# HORSHAM DISTRICT COUNCIL CONSULTATION

| **LOCATION:** | Old Clayton Boarding Kennels Storrington Road Washington West Sussex |
| **DESCRIPTION:** | Application for Approval of Details Reserved by Condition 7 (underground services), 12 (finished floor levels), 14 (landscape management plan) and 27 (biodiversity lighting design) to approved application DC/23/0701 (Demolition and erection of a 60-bed care home and 8No. age restricted bungalows with associated works).<br>Approval of details reserved by conditions 9 (foul drainage), 10 (Surface water drainage), 11 (sustainable drainage components) and 22 (sustainable drainage management and maintenance) to approved application DC/23/0701 (Demolition and erection of a 60-bed care home and 8No. bungalows). |
| **REFERENCE:** | DISC/25/0051<br>DISC/25/0076 |

Blue indicates the storage crate, red indicates the 3m foul easement, green indicates trees and turquoise indicates wetland and/or rain garden planting. See summary.

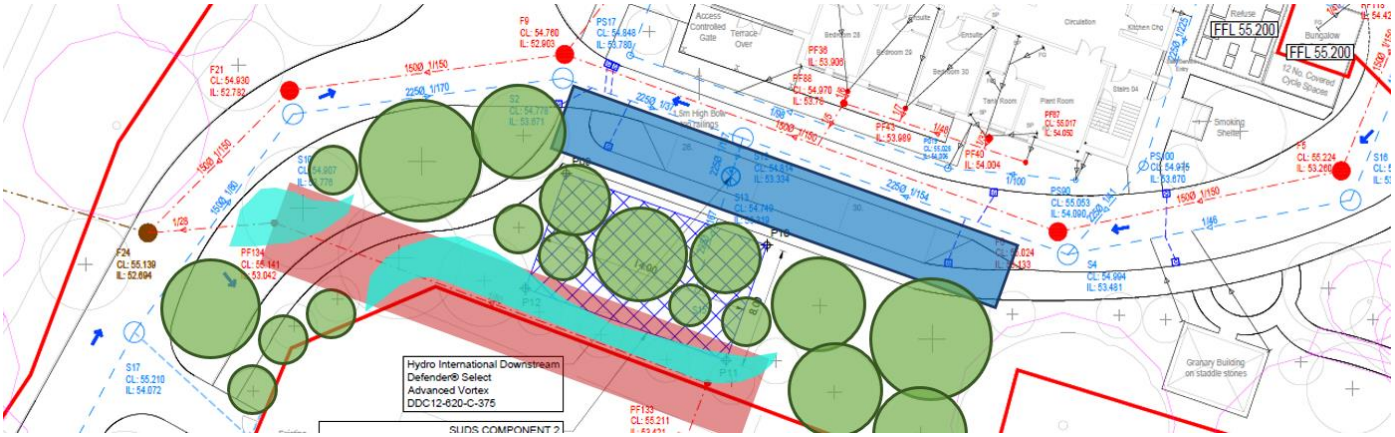
We continue to advise that the attenuation storage is located below hard surfacing, however if sound rationale can be provided otherwise, then we would prefer the original layout submitted under 024.5063-0501 C02.

5. While there is no direct conflict with the attenuation crate and proposed trees within the current drainage layout, it does not allow for the enhanced native woodland buffer, proposed and approved as part of the landscape mitigation under DC/23/0701. The alternative attenuation layout suggested on 01/07/2025 aimed to address this issue and provide a more robust landscape buffer, aligning with the principles considered in support of the outline scheme. However, it remains unclear why this layout cannot be implemented, as no explanation appears to have been provided. For reference, the layout is resubmitted below:

6. If there is a sound rationale for diluting the landscape mitigation strategy, we consider the original drainage layout in this area to be preferable. The longer continuous strip of woodland planting provides more effective visual screening when appreciated from the South Downs, compared to the current proposal. The square configuration of the storage crate creates a void within the buffer zone, thereby reducing the effectiveness of the mitigation strategy. See summary.
7. We note from the email dated 18/07/2025 that only 3no. trees can be provided in the below location as opposed to the 4no. previously approved. Closed.
